# 802.3ba CR4/10, SR4/SR10 loss budgets

Marco Mazzini, Mark Gustlin, Lin Shen,  
Gary Nicholl, Pirooz Tooyserkani - Cisco  
John D'Ambrosia – Force10 Networks

IEEE P802.3ba  
July 2009 San Francisco

Figure 85-2—40GBASE-CR4 and 100GBASE-CR10 link (half link is illustrated)

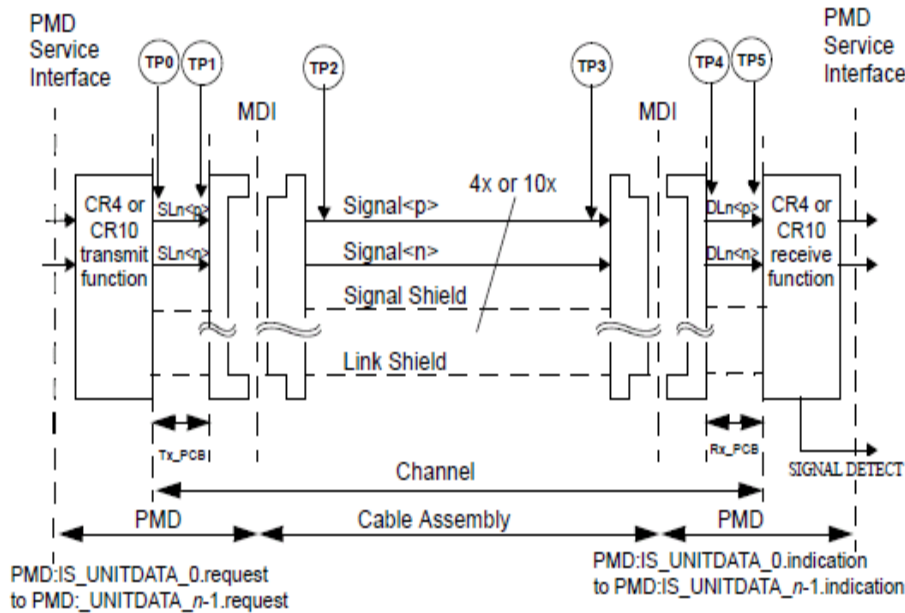
- The CR4/CR10 PCB loss allowances are not sufficient for future PCB board designs, and do not support 4” of standard PCB trace
- Clause 86A and 85 are not consistent in their PCB loss budgets.  
See daw\_05\_0509 for comparison based on D2.0
- We need to allow for integration of multi-port PHYs, stacked connectors, and reasonably priced PCB materials (included lead free considerations)
- We need loss budget for reflections, stubs and other impairments

The 40GBASE-CR4 and 100GBASE-CR10 channel is defined between the transmitter (TP0) and receiver blocks (TP5) to include the transmitter and receiver differential controlled impedance printed circuit board insertion loss and the cable assembly insertion loss as illustrated in Figure 85-2. Annex 85A provides information on parameters associated with test points TP0 and TP5 that may not be testable in an implemented system. All cable assembly measurements are to be made between TP1 and TP4 as illustrated in Figure 85-2. Two mated connector pairs have been included in the cable assembly specifications defined in 85.10.

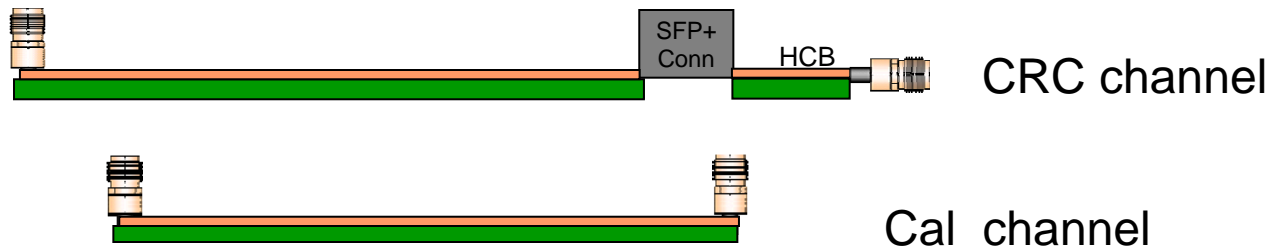
- With FR4-6 material (or equivalent), Cisco estimates a PCB loss of around 0.8dB/inch, as measured over Cisco Ref card (CRC, for SFP+ testing)
- Lead-free materials further limits the PCB material choices

- **Current 802.3ba draft 2.1 limits PCB designs to be from 1.5" minimum to 3" maximum, with FR4-6 material or equivalent: this is not in line with the 8" (4" per side) requirement in 85A.4.**
- Note: CRC uses 4.25 mil traces, 8.5 mil spacing,  $DK = 3.8$

## Channel Layout Example

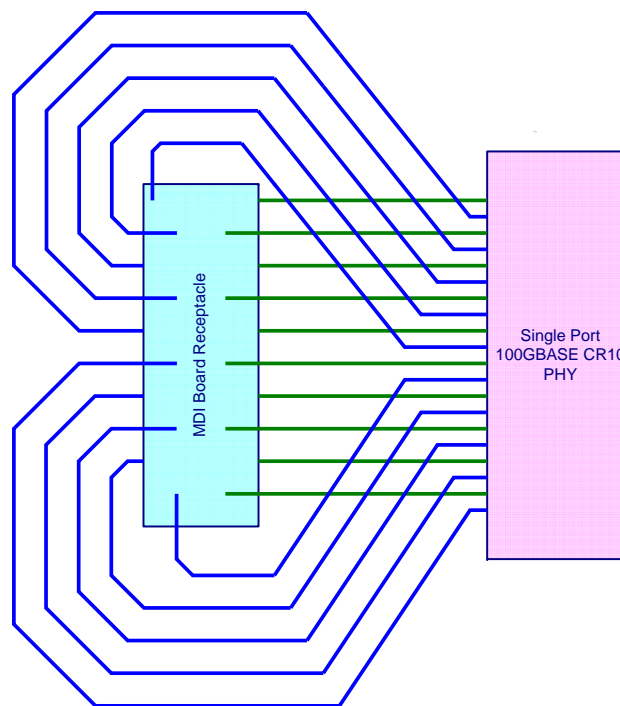
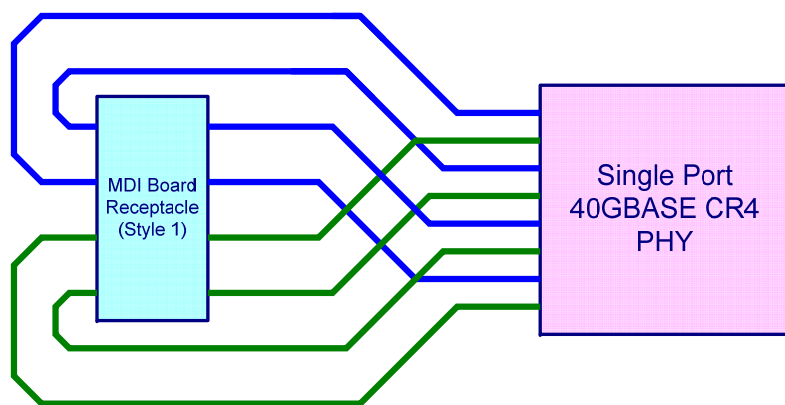
- Taking into account future multi-port designs:
    - PCB impedance variation ( $\pm 10\%$ ),
    - Routing layer used (this leads to stubs),
    - Connector pin field design
    - Reflections/resonances between individual components
    - Many discrete components are not shown these constrain the PHY placements
- All the above affect the loss budget

**Proposal is to allocate a total of 5dB max loss for PCB and Host connector (3.5dB for PCB, 0.87dB for connector, 0.63dB for other impairments).**

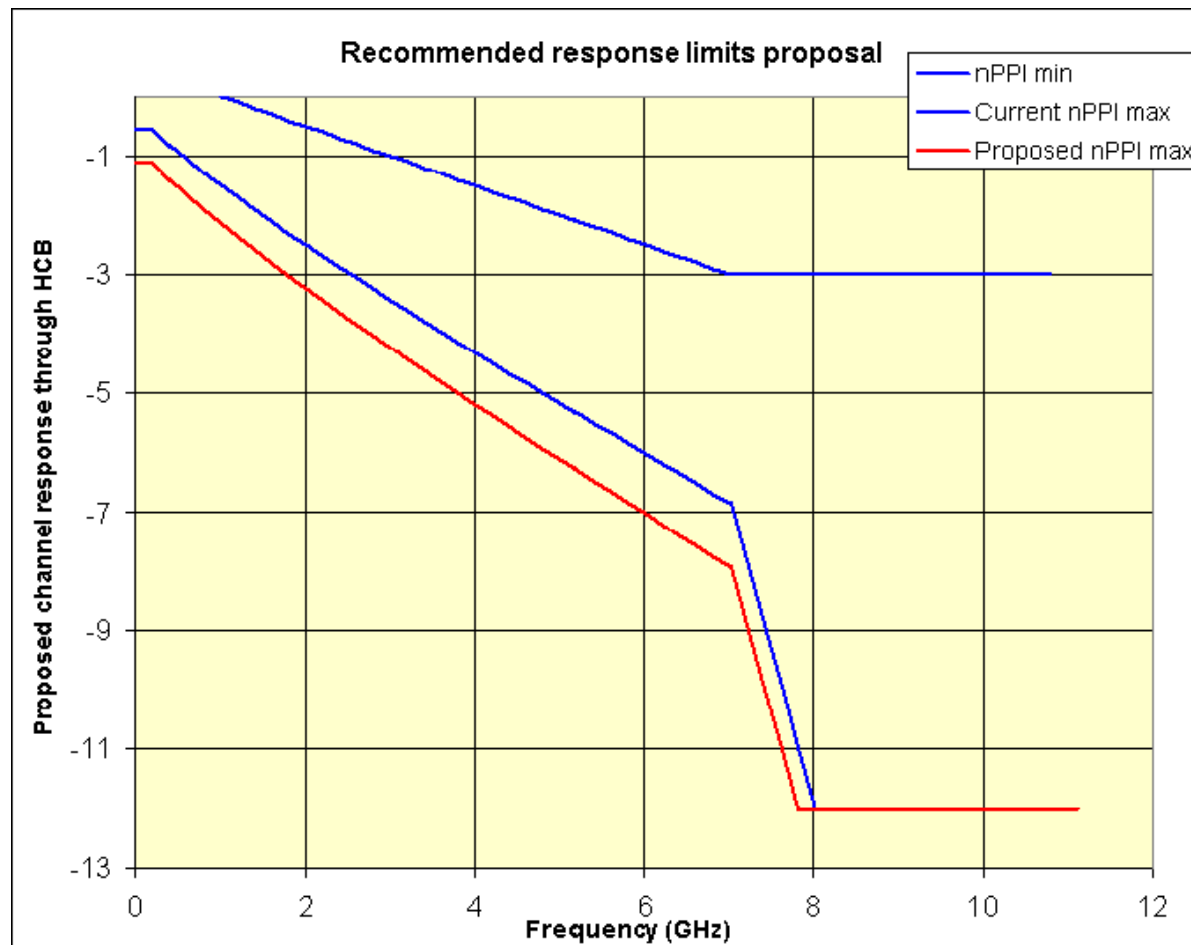
To allocate this budget, a trade off between CR4/10 cable and PCB loss can be considered.

We do not foresee a significant reduction of copper connections by moving the target maximum CR4/CR10 cable distance from 10 to 7m.

If this can be applied to CR4/10 802.3ba, then a 7m cable would allow such PCB loss to keep the same max channel loss.

Considering a cable assembly loss reduction of 6dB from 10 to 7m (2dB/m), then this loss would become:

$$21.55\text{dB} - (3 \times 2\text{dB}) = 15.55\text{dB} \rightarrow \text{assuming } 16.3\text{dB}$$

$$\text{Max channel loss (10m)} = 26.3\text{dB in the draft 2.1}$$

$$\text{Proposed would give Max channel loss (7m)} = 16.3 + 5 \times 2 = 26.3\text{dB}$$
